Item ID: D3394-1RG Accept ***N900040100*** Setup Start ***NS1***
Revision ID: Stop ***NS2***
Item Name: Lug
Start Date: 10/28/2016 Start Qty: 2.00 ***2*** Cust Item ID:
Required Date: 10/31/2016 Req'd Qty: 2.00 ***2*** Customer:
Reference: S0128266

DRAWING NO.	D3394	TITLE	LUG	REV. B	DART AEROSPACE LTD ENGINEERING ORDER	D.E.O. NO.	D3394-B-1	SHEET NO.	SHEET 1 OF 1	SCALE	NTS
DRAWN	AJS	CHECKED		MFG. APPR.		APPROVED		DE APPR.			
DATE	09.11.04	DATE	09.11.04	DATE	09.11.04	DATE	09.11.04	DATE	09.11.04

DRAWING NO. D3394	TITLE LUG	REV. B	DART AEROSPACE USA, INC ENGINEERING ORDER		D.E.O. NO. D3394-B-2	SHEET NO. SHEET 1 OF 1	SCALE NTS
DRAWN 92	CHECKED SC	MFG. APPR. M	APPROVED MP		DE APPR. H		
DATE 11.05.02	DATE 11.05.09	DATE 11.05.09	DATE 11.05.09		DATE 11.05.09

SHEET 4 ZONE A,1 MODIFY SECTION A-A AS SHOWN:

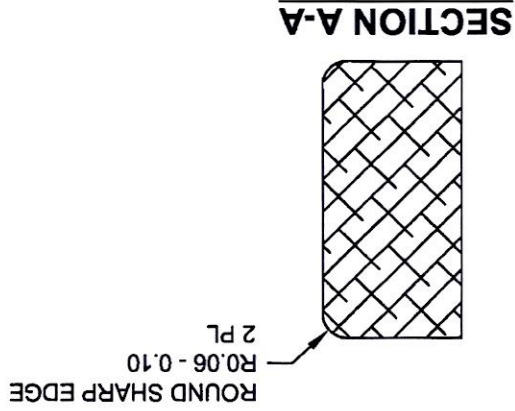
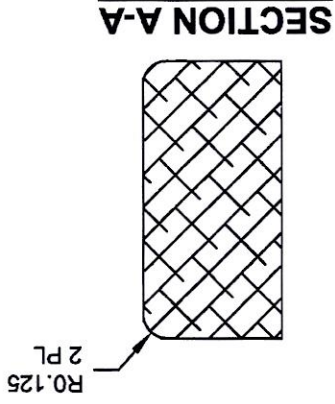
REASON: DRAFTING ERROR

IS:

WAS:

D3394-1RG LUG (SHOWN)
D3394-3RG/-5RG LUGS (SIMILAR)
D3394-041RG/-043RG/-045RG LUG ASSEMBLIES (SIMILAR)

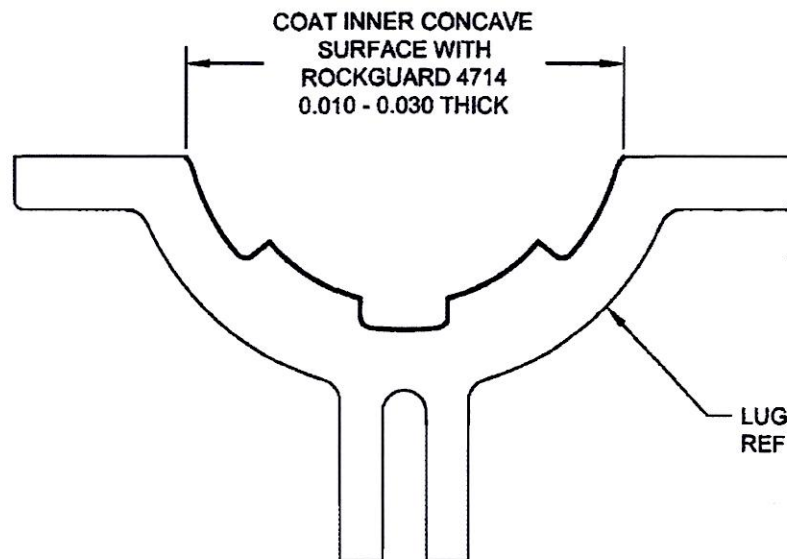
ADD D3394-xRG OPTION

D3394-xRG MOUNTING LUGS ARE INDENTICAL TO D3394-x MOUNTING LUGS, HOWEVER AFTER FINISH, COAT INNER CONCAVE SURFACE WITH "PLUS ONE ROCKGUARD 4714" AS SHOWN BELOW.
